DOCKET ITEM #12
Hoffman Block 2 - TSA
CDD Concept Plan Amendment #2014-0006
Stage II Development Special Use Permit #2014-0045
Vacation #2014-0006

Purpose of Application
Approval of a: (A) Amendment to a previously approved (#2014-0004) Coordinated Development District plan to transfer parking spaces from Block 4 to Block 2; (B) Stage II Development Special Use Permit and site plan (with modifications) to construct an office building and an above-ground parking structure; and, (C) vacation of a public right-of-way, zoned CDD#2 (Eisenhower East Small Area Plan).

Staff Recommendation: APPROVAL WITH CONDITIONS
Staff Reviewers: Gary Wagner, PLA, RLA gary.wagner@alexandriava.gov Trey Akers, AICP, LEED AP BD+C trey.akers@alexandriava.gov

Tower 203 Turning Specifications

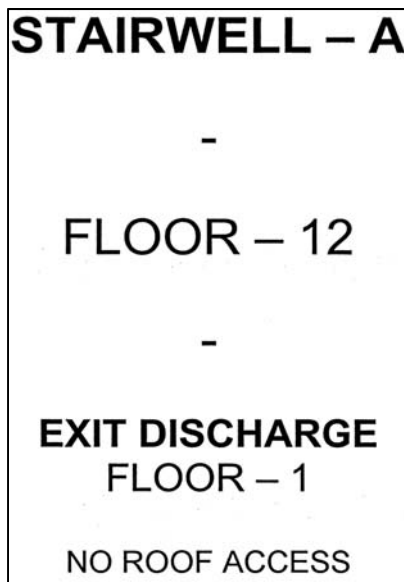
- <http://alexandriava.gov/uploadedFiles/tes/info/MemoToIndustry06-14.pdf>
- C - 9 Per the requirements of Title 4, Chapter 2, Article B, Section 4-2-21, Appendix A, Section A 106(6), Figure A 106.1 Minimum Standards for Emergency Vehicle Access: provide a total turning radius of 25 feet to the satisfaction of Directors of T&ES and Office of Building and Fire Code Administration and show turning movements of standard vehicles in the parking lot as per the latest AASHTO vehicular guidelines. (T&ES)

Applicant has provided requested information.

Ex. Stairway Identification Sign

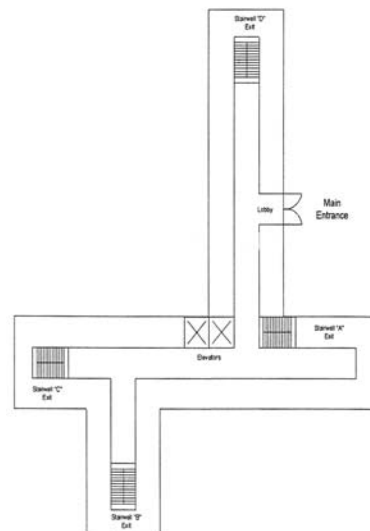
C - 9 Provide Stairway Identification. Stairway identification signs shall be provided at each landing in all interior exit stairways connecting more than three stories. Stairways shall be identified by letter designation starting next to the main entrance with "A" and continuing in a clockwise or left to right pattern using consecutive letters of the alphabet for each additional stairway. Two copies of the stairway signs shall be submitted to the fire official for approval before occupancy.

Applicant has agreed to this requirement.
